UNITED STATES PATENT AND TRADEMARK OFFICE

10/596,362

Shigeyuki Hamayoshi

Office Action Summary	Application No. 10/596,362	Applicant(s) HAMAYOSHI ET AL.	
	Examiner SARANG AFZALI	Art Unit 3726

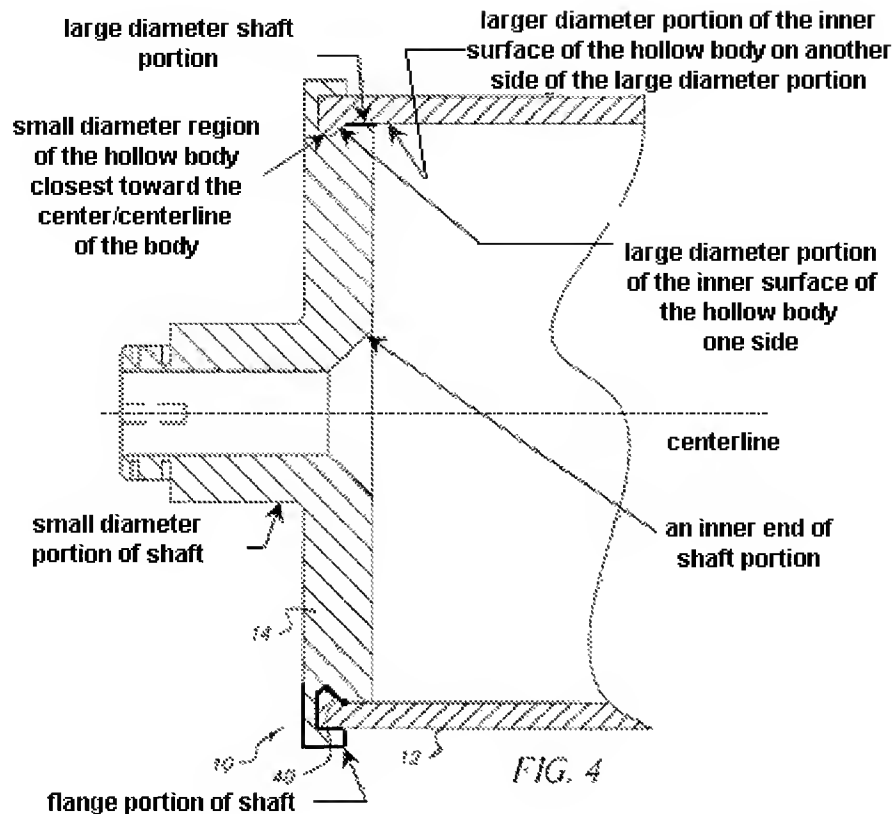
Kass et al. teach a hollow body with shaft portions connected to the said body capable of operating at elevated temperature (col. 1, lines 7-10, Fig. 4).

As applied to claim 5, Kass et al./Imamura et al./Hamayoshi teach the invention cited. Kass et al. further teach the roll wherein the inner surface of said body comprises large-diameter regions on both sides and a small-diameter region in the center, and each of said shaft portions has a small- diameter portion, a flange and a large-diameter portion, the large-diameter region of said body being connected to the large-diameter portion of said shaft portion.

As applied to claim 7, Kass et al./Imamura et al./Hamayoshi teach the invention cited. Kass et al. further teach the roll wherein each large-diameter region of said body is shrink-fit to the large-diameter portion of each shaft portion (Fig. 4 above, col. 4, lines 7-10).

As applied to claims 9, 10 and 12, Kass et al./Imamura et al./Hamayoshi teach the invention cited. Kass et al. further teach the roll wherein a ratio of the inner diameter of each small-diameter region of said body to the inner diameter of each large-diameter region of the body is 0.9 or more and less than 1.0 (as in claim 9 shown in Fig. 4 above); that the large-diameter region of said body is longer than the large-diameter

portion of said shaft portion, so that there is a gap between the end of each small-diameter region of said body and the inner end of said shaft portion (as in claim 10 shown in Fig. 4 above) and that a ratio of the outer diameter of said body to the outer diameter of the small-diameter portion of each shaft portion is 2-10 (as in claim 12 shown in Fig. 4 above).

As applied to claim 8, Kass et al./Imamura et al./Hamayoshi teach the invention cited. Kass et al. (Fig. 4 above) further teach a shrink-fit connection between the shaft portion and the hollow body. However, the limitation of "shrink fitting ratio in a range of 0.01/1000 to 0.5/1000" is not given any patentable weight since both claims 7 and 8 are considered product-by-process claims and this product by process limitation is already taught by the structure of Kass et al./Imamura et al./Hamayoshi and this extra limitation of the shrink fit ratio does not have any effect on the overall structure. Furthermore, it would have been obvious to one of ordinary skill in the art at the time of invention to have selected the claimed shrink fit ratio range to the roll of Kass et al./Imamura et al./Hamayoshi in order to provide an effective and secured shrink fit connection of the parts without subjecting the joint to any extra stresses.

As applied to claim 11, Kass et al./Imamura et al./Hamayoshi teach the invention cited. Kass et al. (Fig. 4 above) further teach a ratio between the effective length to the outer diameter of the large-diameter portion of each shaft portion but do not explicitly teach the claimed range.
